METROPOLITAN GOVERNMENT OF NASHVILLE AND DAVIDSON COUNTY

STAFF RECOMMENDATION
1506 Cedar Lane
September 19, 2012

Application: New construction—addition to primary structure and alteration to accessory structure.

Applicant: Nick Dryden, DA/AD

1 SITE PLAN
 Scale: 3/32" = 1'-0"

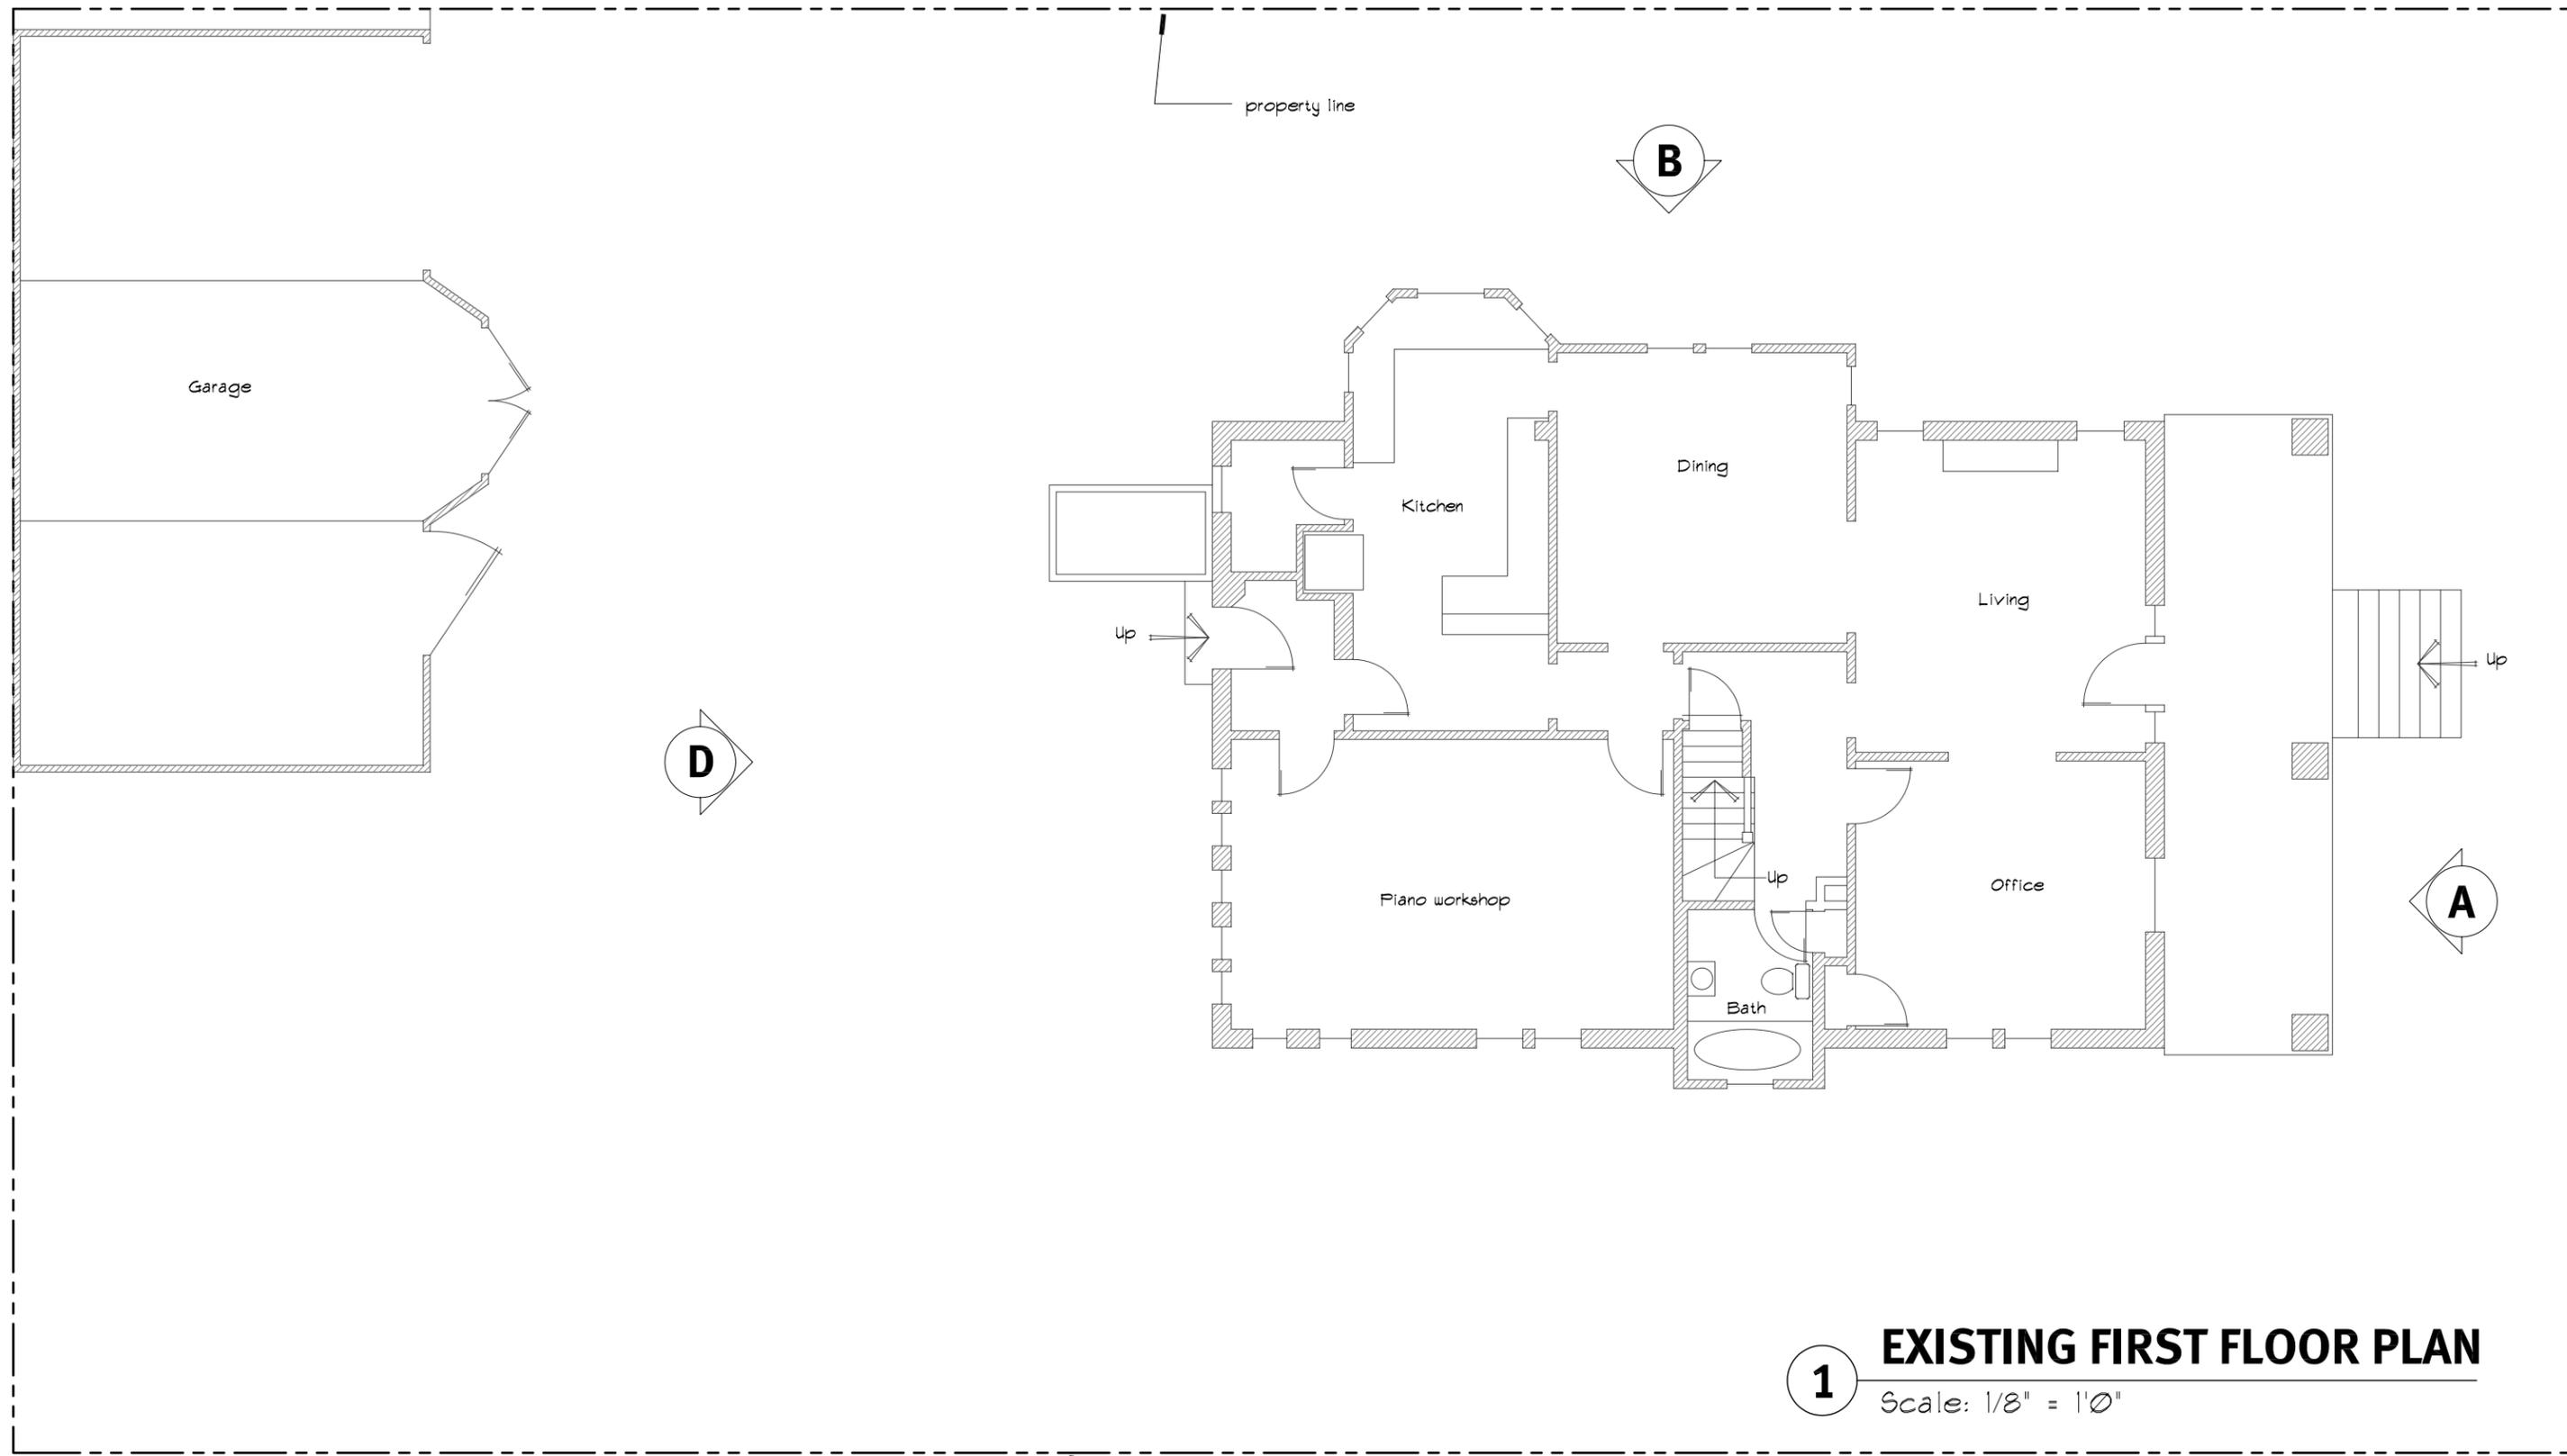
Location and Setback: 1506 Cedar's lot is seventy feet (70') wide, which is wider than the typical lot in the immediate historic context. The proposed addition meets all base zoning requirements for setbacks. It is located behind the back wall of the house. It initially steps in two feet (2') from each of the house's sidewalls, but on the left side, the addition expands to be approximately fourteen feet, three inches (14'3") wider than the historic house after a depth of five feet, four inches (5'4").

Staff finds that the location of proposed addition meets the design guidelines for several reasons. Because the lot is unusually wide, a wider addition is appropriate. The wider portion of the addition is less than one-half the width of the house, which is approximately thirty-feet, four inches (30'4") wide, and is significantly shorter than the house. It is just one-story and sixteen feet, nine inches (16'9") tall, which is a little more than eight feet (8') shorter than the one-and-a-half story existing house. The addition's hipped roof form will also help to minimize the perceived height of the house. Lastly, the wider portion of the addition is offset from the historic house with a structural alcove that is two feet (2') wide and five feet, four inches (5'4") deep, which will help distinguish the old from the new.

The existing accessory structure does not meet the base zoning requirements for setbacks. It sits on the rear property line and is just one foot (1') from the right side property line. However, because the existing accessory structure will not be demolished, and its footprint and walls will remain, a setback reduction is not required.

C **EXISTING SOUTH ELEVATION**
Scale: 1/8" = 1'0"

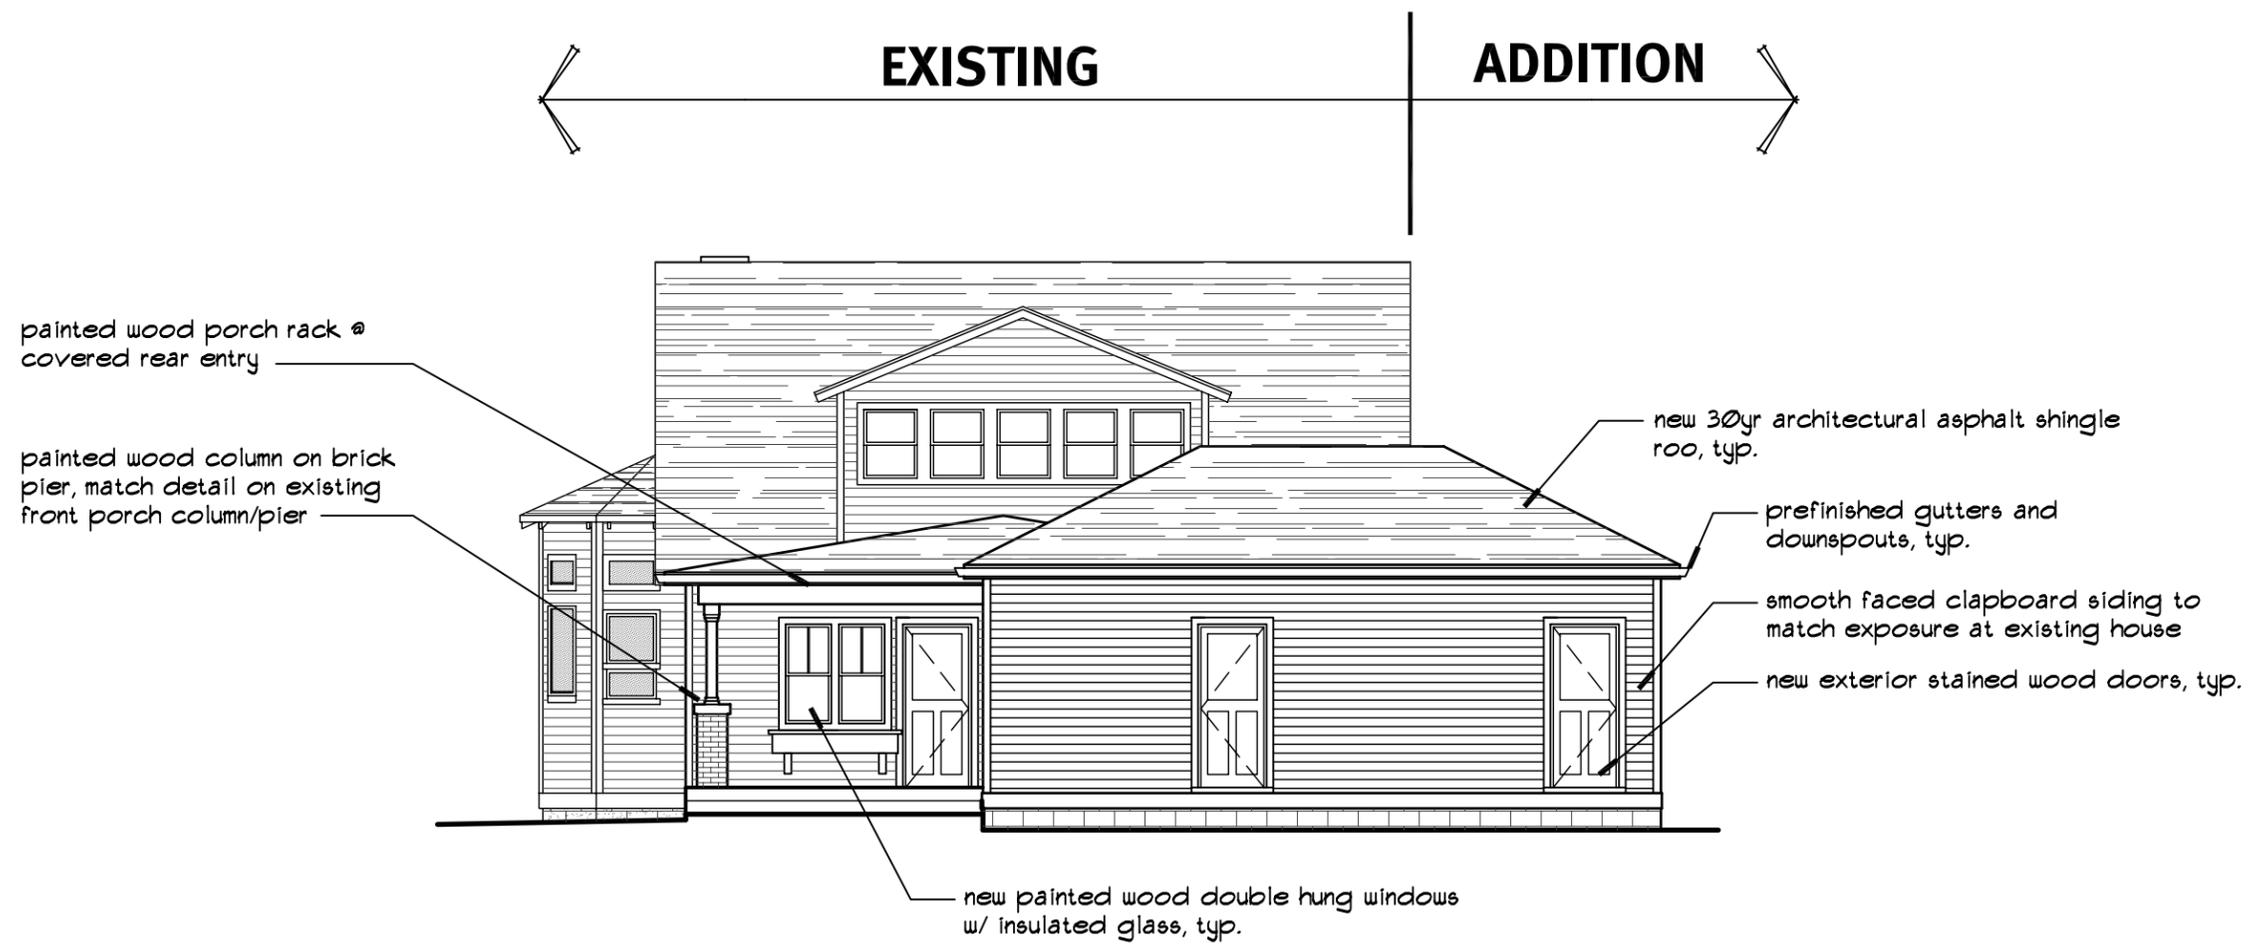
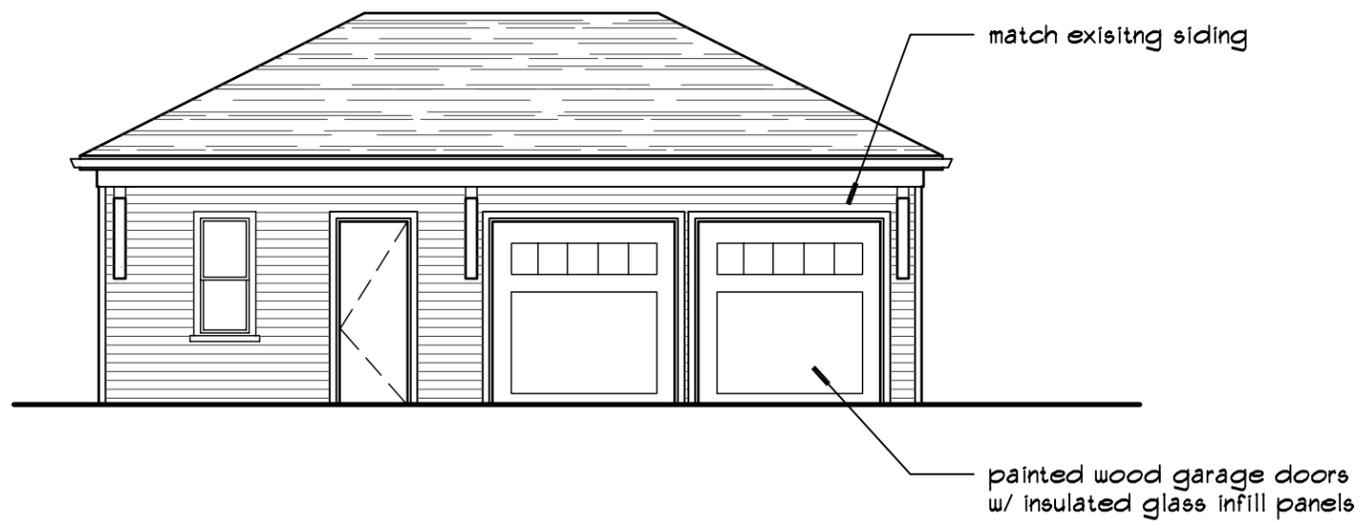
Roof: The existing house has a side gabled roof with a slope of approximately 6/12. The portion of the addition that is wider than the historic house has a hipped roof, with a 6/12 slope, which will help to minimize its height. The portion of the addition that is inset from the house's sidewalls also has a hipped roof, with side slopes of 2/12 and a back slope of 3/12. Staff finds that the addition's roof pitches and forms to meet Section II.B.1.e. and II.B.2.a. of the *Belmont-Hillsboro Neighborhood Conservation Zoning Overlay: Handbook and Design Guidelines*.

Proportion and Rhythm of Openings: The windows for the addition are generally taller than they are wide and meet the design guidelines. The largest expanse of wall space without a window or door opening occurs on the west elevation, where there are two spaces of approximately twelve feet (12') of blank wall space. Staff finds these two expanses to be acceptable in this instance because they are less than fifteen feet (15'), are inset from the house's sidewalls, and occur beyond the back wall of the house. They therefore will be at most minimally visible.

F **FRONT ELEVATION- GARAGE**
 Scale: 1/8" = 1'0"

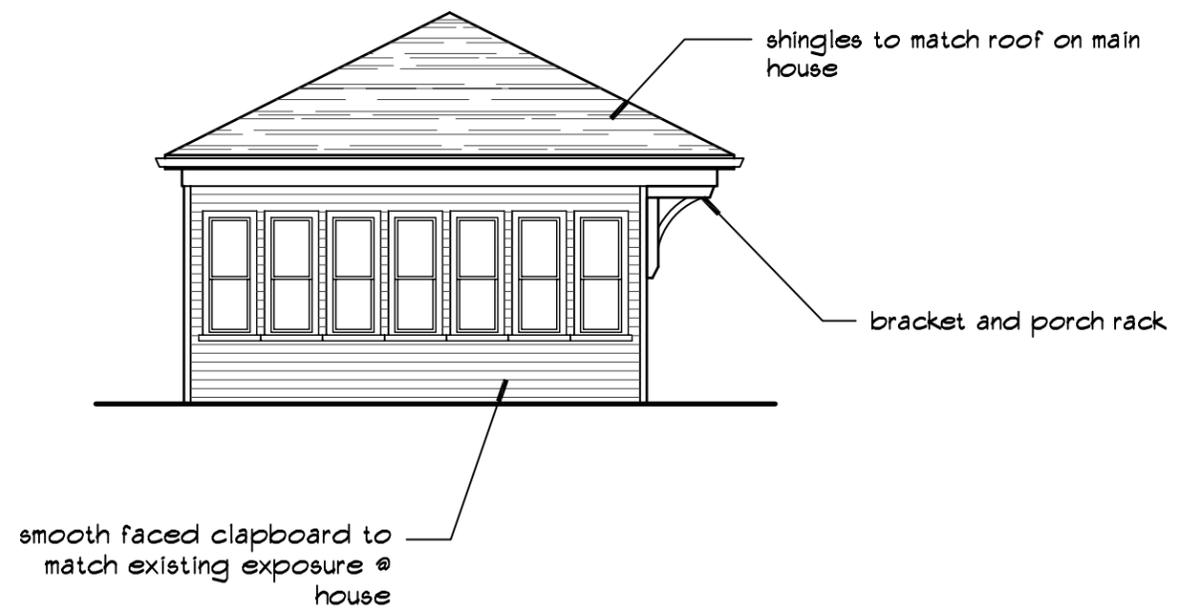
The accessory structure is thirty-six feet (36’) wide and twenty feet (20’) deep. Its footprint totals seven hundred and twenty square feet (720 sq. ft). The structure’s height and roof form will change. The garage will remain one story, and will have an eave height of approximately ten feet (10’) and a ridge height of approximately seventeen feet (17’), which is subordinate to the historic structure. The structure’s roof will be hipped with a slope of 6/12.

The materials for the accessory structure will be similar to those proposed for the addition to the house. The structure will be re-clad in smooth-face cement fiber or wood lap siding with an exposure to match the siding on the house. The windows and the doors, including the garage doors, will be wood, and the roof will have asphalt shingles to match those on the house. The proportion and rhythm of openings for the accessory structure are appropriate for outbuildings. Although the site does have an alley, the accessory structure will be accessed via an existing curb cut and driveway. Staff finds this appropriate since this reflects the current conditions of the site (see photo below).
